# AltoUpdate...

## Solve Clutch Pack Clearance Problems... Buick, Chevrolet, Oldsmobile & Pontiac

MAKE	TRANSMISSION	APPLICATION	YEAR
GM	4T65E	2nd Clutch Selective Steel Plate	Various
DESCRIPTION & NOTES...

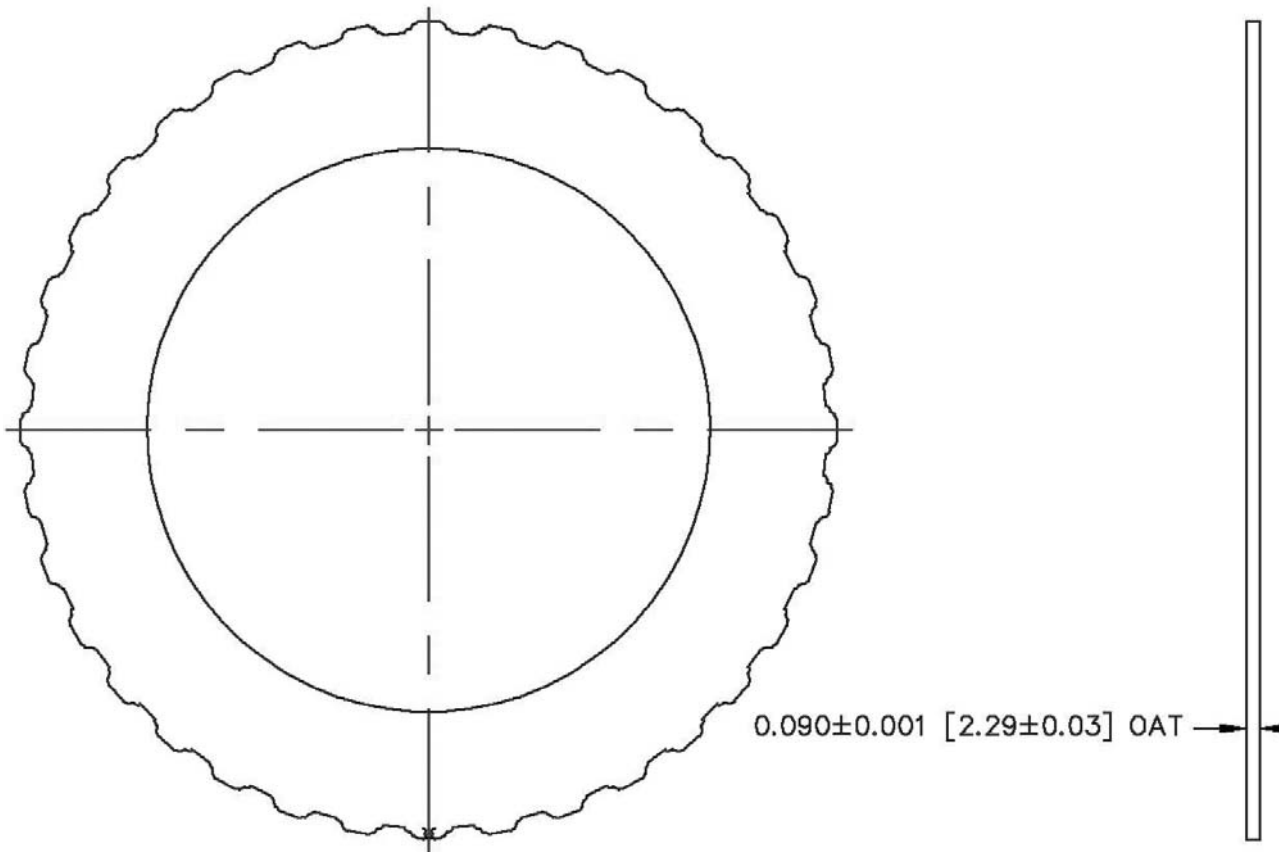
The GM 4T65E 2nd clutch pack has no provision for clutch pack clearance adjustment. The normal stack-up takes five steels at .068" thick (Alto#062733) and six friction plates at .070" thick (Alto#062722). Historically the 2nd clutch pack has too much clutch pack clearance, by using the 062733-228 that is .090" thick; in combination with OE thickness steel plates the clutch pack can be adjusted.
